**SUBDIVISION &
SIDEWALK WAIVER STAFF REPORT****Date: December 16, 2010****NAME**

Steiner Properties Subdivision, Resubdivision of Lots 2, 3 & 4

Northwest corner of Larue Steiner Road and U. S. Highway 90 West

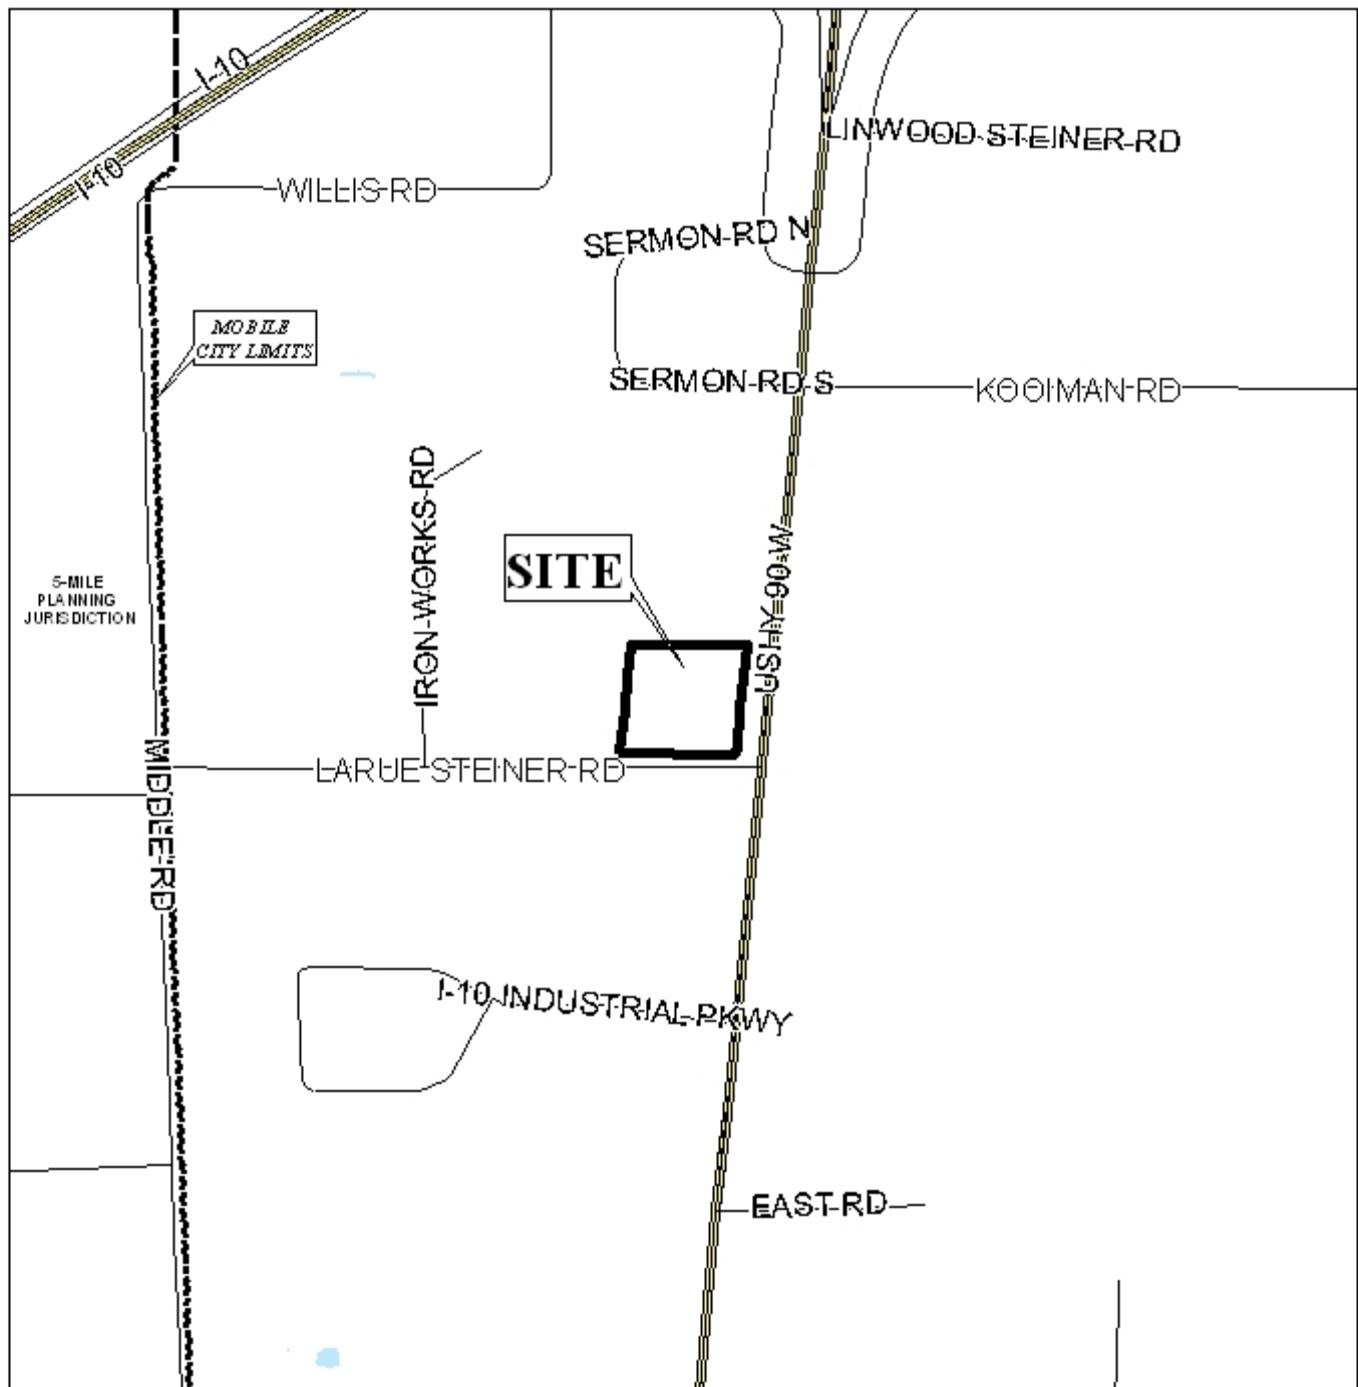
The site has frontage onto U. S. Highway 90 West, a proposed major street, and Larue Steiner Road, a minor street. The preliminary plat depicts an existing 160-foot wide right-of-way for U. S. Highway 90, however, the Major Street Plan component of the Comprehensive Plan requires a minimum right-of-way width of 250 feet at this location: adequate right-of-way should be dedicated to provide 125 feet, as measured from the centerline, including the provision of a corner radius at Larue Steiner Road. The existing right-of-way for Larue Steiner Road is 80 feet, which is adequate for a minor street.

The plat shows the 25-foot minimum building setback line from both roads, and includes an additional 35-foot setback from U. S. Highway 90 West, as required by the Planning Commission in its approval at its March 16, 2000 meeting for the previous subdivision creating the current lots.

The plat has a note indicating the proposed lot size in acres, however, it should also be shown in square feet, and should also reflect any required dedication.

A site plan was submitted with the application in order to depict requested curb-cuts. One right-in, right-out curb-cut is depicted on U. S. Highway 90 West, and two curb-cuts are depicted onto Larue Steiner Road. U. S. Highway 90 West is an ALDOT regulated facility with a median at this location, thus any curb-cuts onto the road will require their approval in addition to Traffic Engineering approval. The proposed lot should be limited to one curb-cut onto U. S. Highway 90 West, and two curb-cuts onto Larue Steiner Road, with the size, location and design to be approved by Traffic Engineering and ALDOT, and to conform with AASHTO standards.

- 2) Dedication of right-of-way along U. S. Highway 90 West sufficient to provide 125 feet as measured from the centerline, including the provision of a corner radius at Larue Steiner Road;

- 3) Placement of a note on the final plat stating that the lot is limited to one curb-cut onto U. S. Highway 90 West, and two curb-cuts onto Larue Steiner Road, with the size, location and design to be approved by Traffic Engineering and ALDOT, and to conform with AASHTO standards;

- 4) Depiction of the 25-foot minimum building setback line from all road frontages, reflecting any required dedication;
- 5) Placement of a note on the plat stating the size of the lot in square feet, reflecting any required dedication; and

SIDEWALK CROSS-SECTION DETAIL 1

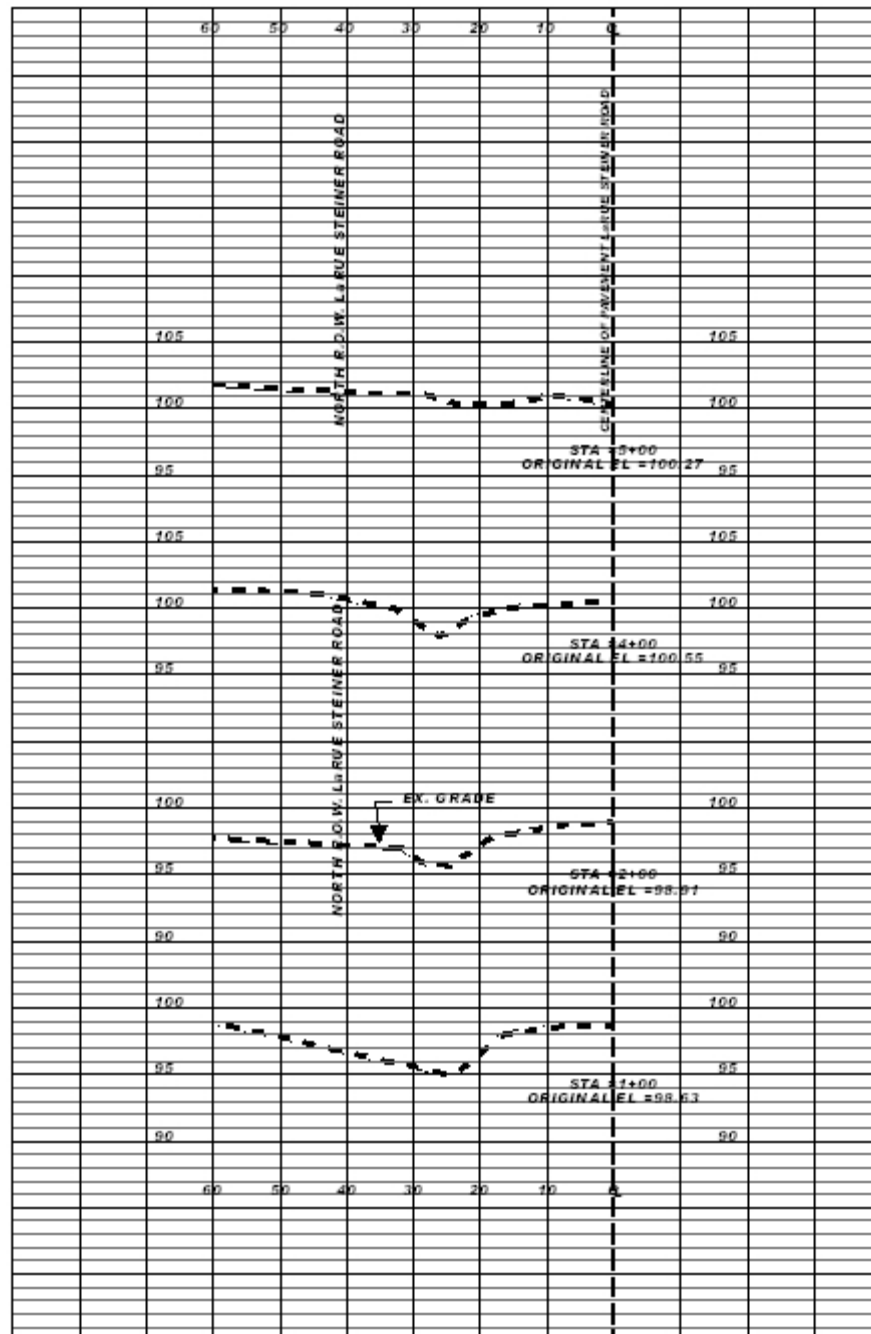
Due to the open drainage ditches along Highway 90 along Larue Steiner, acceptance of sidewalk waiver is recommended.

Regarding the sidewalk waiver request, the applicant states that there are no sidewalks in the vicinity, and that the site fronts open ditches along both road frontages.

Aerial photos from 2010 indicate that there are, in fact, no sidewalks in the vicinity of the site. While the proposed use may not generate pedestrian traffic, the location next to a proposed major street and a street that appears to support truck traffic would justify the provision of a sidewalk if feasible.

Sidewalk Waiver: Based upon the preceding, this request is recommended for Approval.
